Item Name: Crosstube Turning Detail

DART AEROSPACE LTD	Work Order:	105230
Description: Crosstube Assembly (412 High Aft)	Part Number:	D412-664-243
Inspection Dwg: D412-664-243 Rev: E		Page 1 of 2

DRAWING NO D412-664-243	TITLE CROSSTUBE ASS'Y (412 HI AFT)	REV. E	DART AEROSPACE LTD ENGINEERING ORDER		D.E.O. NO. D412-664-243-E-2	SHEET NO. SHEET 1 OF 1	SCALE NTS
DRAWN <i>q</i>	CHECKED <i>AS</i>	MFG. APPR. <i>R</i>	APPROVED <i>W</i>		DE APPR. <i>H</i>		
DATE 11.09.07	DATE 11.09.19	DATE 11.09.19	DATE 11.09.19		DATE 11.09.19

DRAWING NO D412-664-243	TITLE CROSSTUBE ASSEMBLY (412 HI AFT)	REV. E	DART AEROSPACE LTD ENGINEERING ORDER		D.E.O. NO. D412-664-243-E-4	SHEET NO. SHEET 1 OF 3	SCALE NTS
DRAWN 90	CHECKED J	MFG. APPR. J	APPROVED MP		DE APPR. J		
DATE 12.08.21	DATE 12.08.30	DATE 12.08.30	DATE 12/8/30		DATE 12.08.30

**D412-664-243
ASSEMBLY DETAIL**

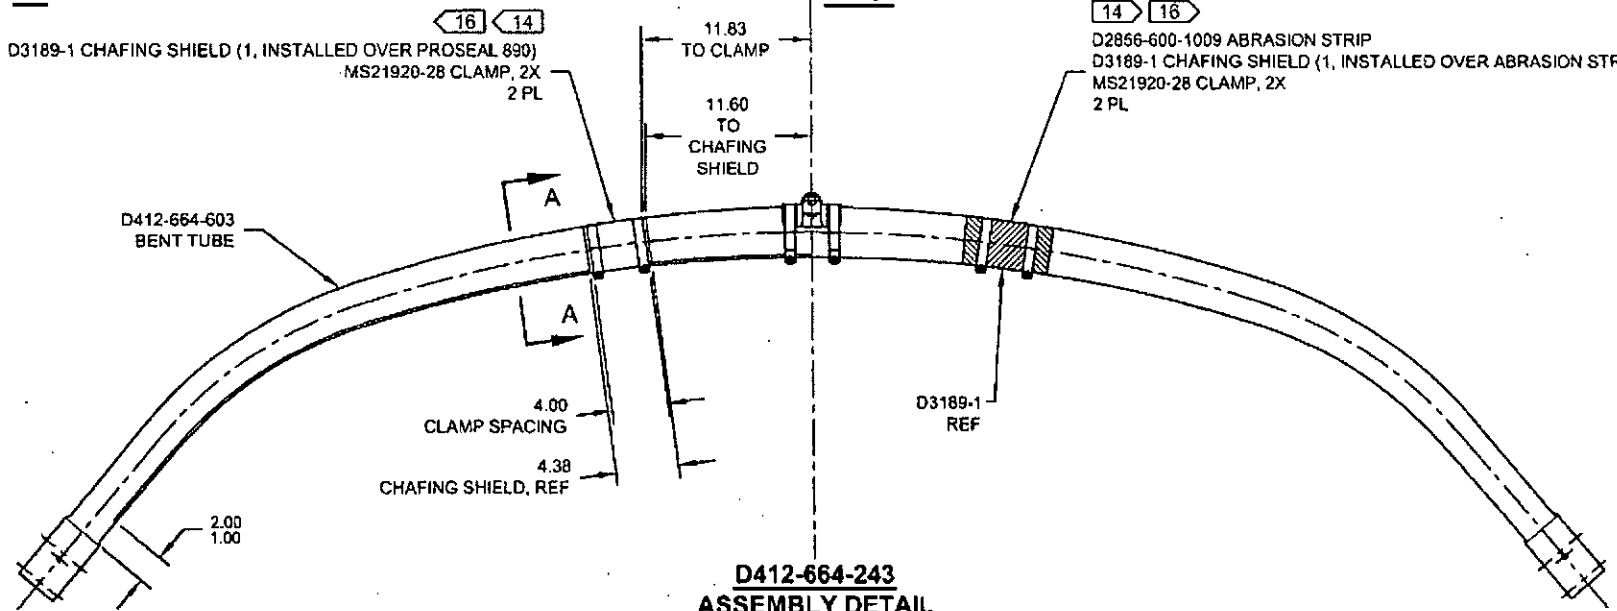
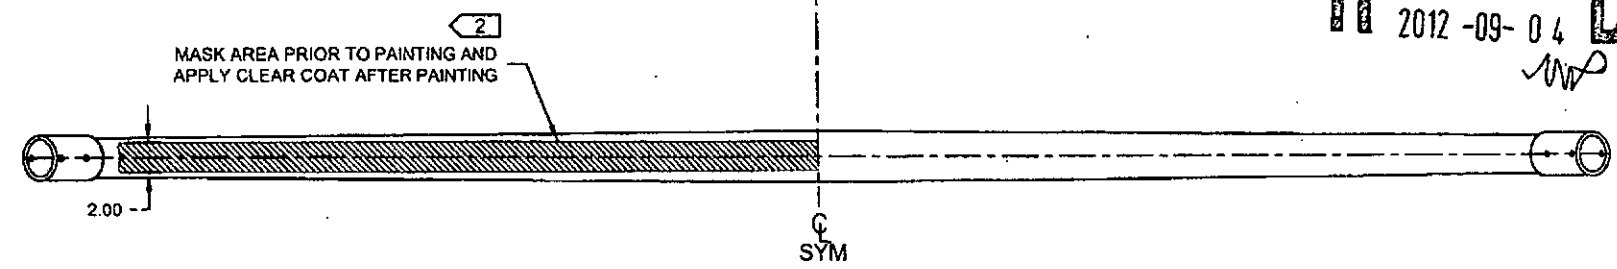
REMOVED ABRASION STRIP IN FAVOR OF A THIN LAYER OF PROSEAL 890. UPDATE INSTALLATION OF CHAFING SHIELDS AND REDUCE TORQUE TO 40-50 IN-LBS. THIS ENGINEERING ORDER SUPERCEDES DEO D412-664-243-E-1.

IS:

D3189-1 CHAFING SHIELD (1, INSTALLED OVER PROSEAL 890)
MS21920-28 CLAMP, 2X
2 PL

WAS:

D2856-600-1009 ABRASION STRIP
D3189-1 CHAFING SHIELD (1, INSTALLED OVER ABRASION STRIP)
MS21920-28 CLAMP, 2X
2 PL

SECTION A-A
CHAFING SHIELD DETAIL
VIEW ROTATED, NOT TO SCALE

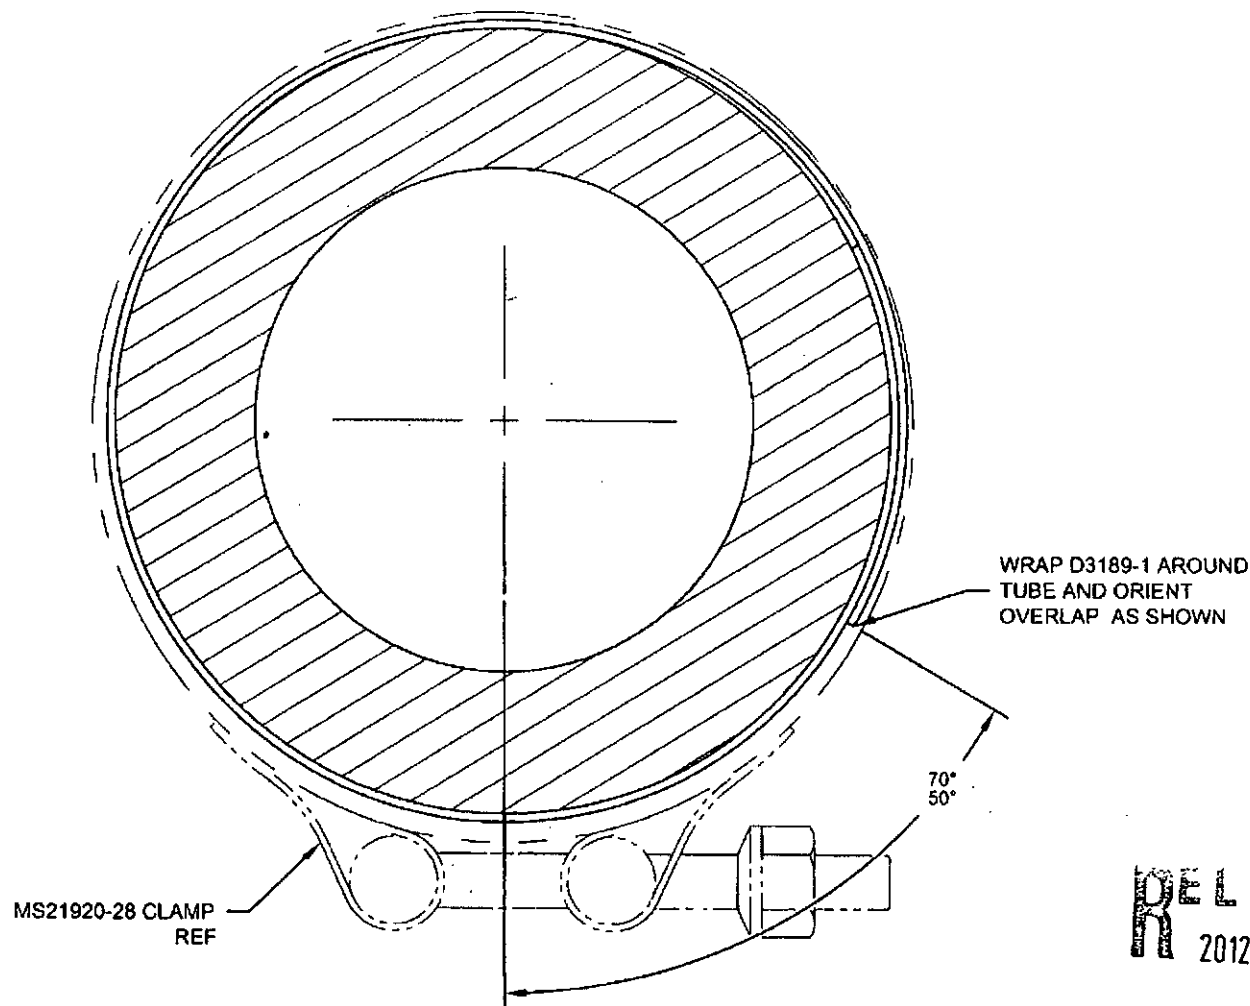
- 2) FINISH: CHEMICAL CONVERSION COAT PER DART QSI 005 4.1
PRIME INSIDE AND OUTSIDE PER DART QSI 005 4.2
MASK UNDERSIDE OF CROSSTUBE AS SHOWN (HATCHED AREA)
PAINT OUTSIDE PER DART QSI 005 4.2
AFTER PAINTING, APPLY CLEAR COAT ON HATCHED AREA
- 14) APPLY A THIN COAT OF PROSEAL 890 ON INSIDE CONCAVE SURFACE OF D3189-1 CHAFING SHIELD AND LET CURE PER MANUFACTURER'S INSTRUCTIONS. INSTALL PROSEALED D3189-1 CHAFING SHIELD ONTO CROSSTUBE BY APPLYING A THIN COAT OF PROSEAL 890 ONTO CROSSTUBE. BE SURE TO ELIMINATE ANY AIR GAPS.
- 16) TORQUE CLAMPS ON D2896-1 SUPPORT 80 TO 100 IN-LB. **TORQUE CLAMPS ON D3189-1 CHAFING SHIELD 40 TO 50 IN-LB.** ENSURE AT LEAST 1.5 THREADS SHOWING IN SAFETY AND THAT NUT HAS NOT BOTTOMED-OUT AFTER TORQUING.
